Your ref: Docket No. 52-006  
Our ref: DCP/NRC1602

**SUBJECT: Transmittal of Westinghouse Responses to Open Items Identified in the AP1000  
Draft Safety Evaluation Report**

**Westinghouse Non-Proprietary Response to  
AP1000 Draft Safety Evaluation Report (DSER) Open Items**

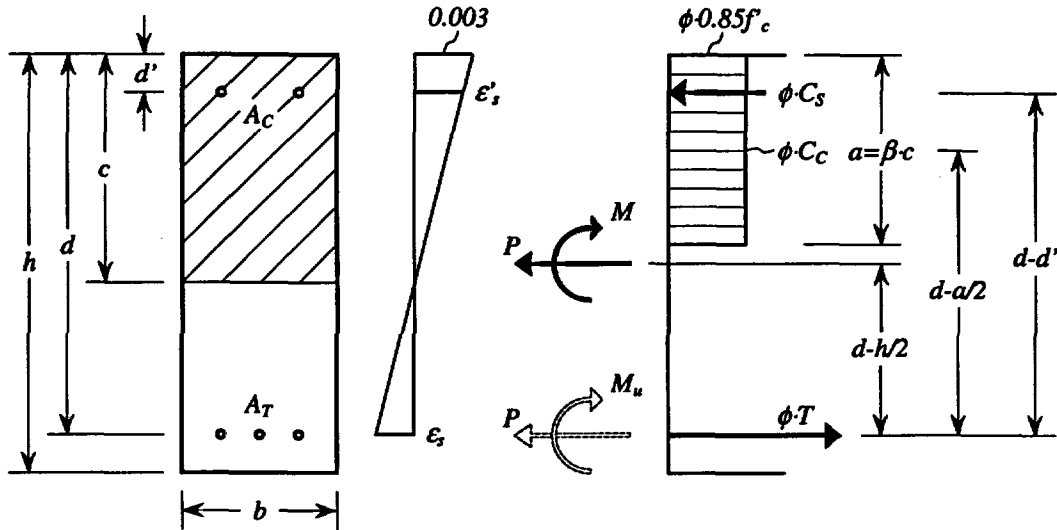
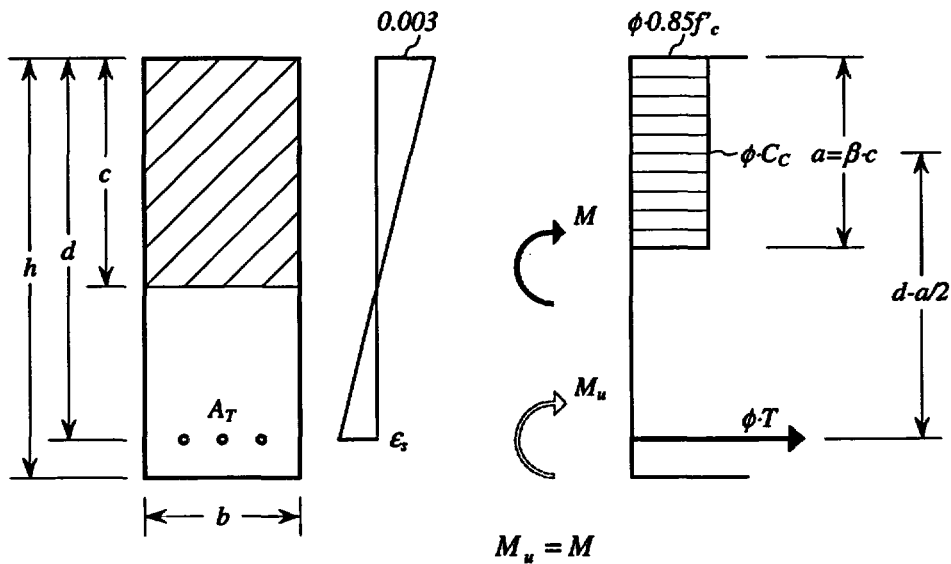
During the course of its review of the Wall 7.3 design calculation, the staff noted that the applicant had previously identified and corrected an error in the equation used by INITEC to calculate the required positive reinforcement for a section subjected to both bending moment and axial load. The staff could not conclude during the audit that the corrected equation accurately calculates required positive reinforcement. Therefore, the applicant was requested to submit the derivation of the equation currently used to calculate the required reinforcement. The applicant was also requested to submit a sample verification calculation for the computer algorithm, and verify that the corrected equation has been utilized in all calculations. This is Open Item 3.8.4.5-2.

The development of the equation for sizing the required reinforcement for a section subject to bending moment and axial load is shown in this response. This equation is applicable when the strength of the section is controlled by yielding of the tension steel and both tension and compression steel, if any, are at yield. Loads and internal forces are shown in the following figures. The design loads  $P$  and  $M$  act at the centroid of the section, where:

The strength reduction factor  $\phi$  is applied to both the steel and concrete strengths to obtain the design strength as shown in the figures.

Compression reinforcement is calculated such that the portion of tension reinforcement not equalized by compression reinforcement ( $A_T - A_C$ ) does not exceed 75% of the  $A_s$  that would produce balanced strain conditions.

The corrected equation as developed herein has been used in all AP1000 calculations of reinforcement using the ANSYS post processors and EXCEL macros.

Figure 2.7.1-1 (Sheet 2 of 2)  
Nuclear Island Nonradioactive Ventilation System

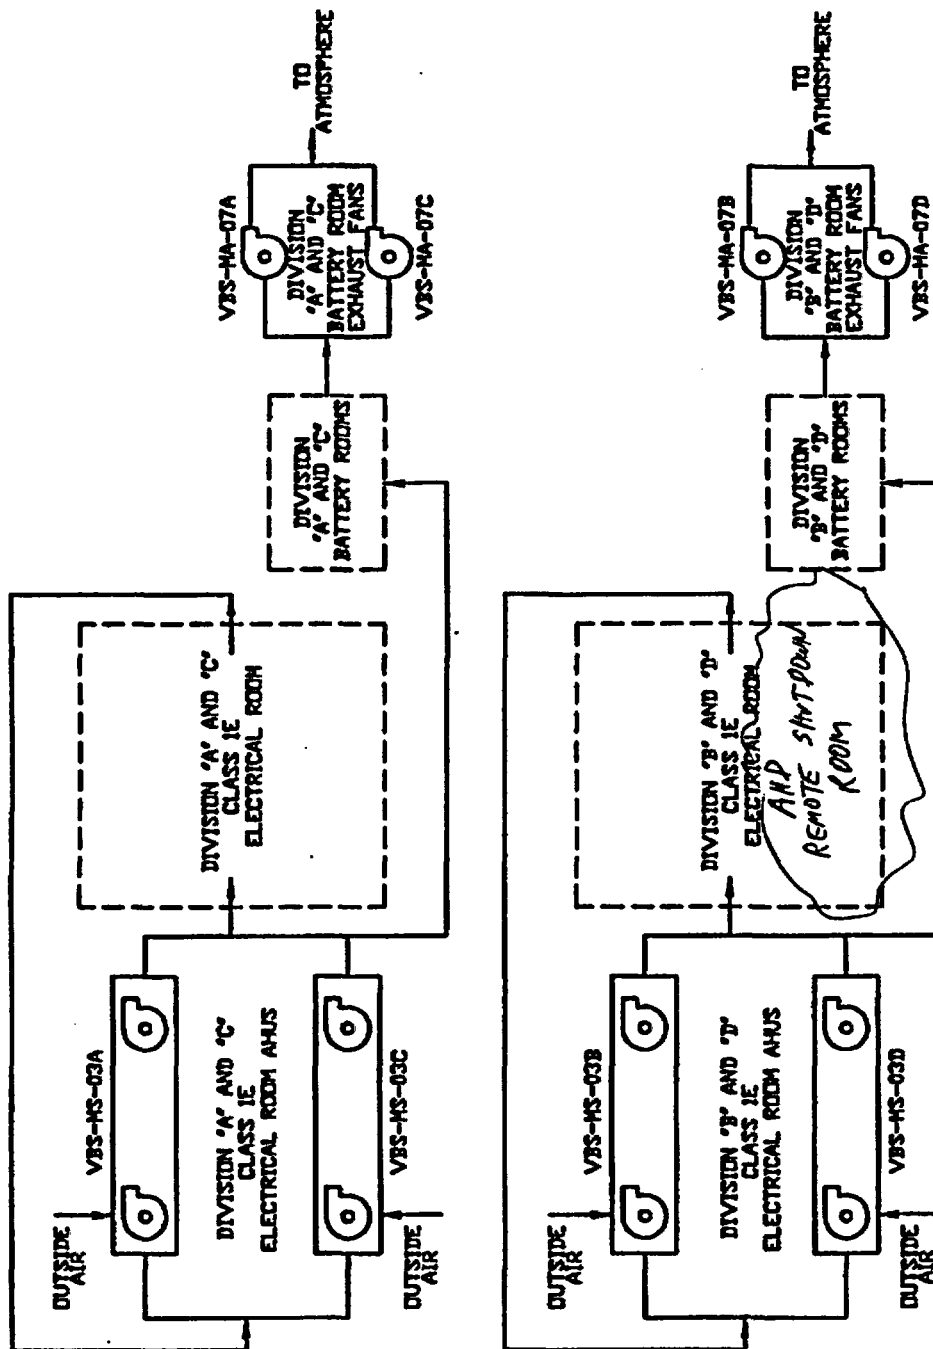
Table 3.2-1, item 10.i: Subsection 2.7.1 does not have an ITAAC related to RSR – there is nothing in the ITAAC that requires inspection, test, and analyses for the RSR and ventilation. Please clarify. This is Open Item 14.3.3-18.

DCD Tier 1 Subsection 2.7.1 will be revised as shown below to resolve the RSR discrepancy.

Table 2.7.1-4 (cont.) Inspections, Tests, Analyses, and Acceptance Criteria		
Design Commitment	Inspections, Tests, Analyses	Acceptance Criteria
Revise item 8a as shown.		
8.a) The VBS provides cooling to the MCR, TSC, RSR, and Class 1E electrical rooms.	See item 12 in this table.	See item 12 in this table.
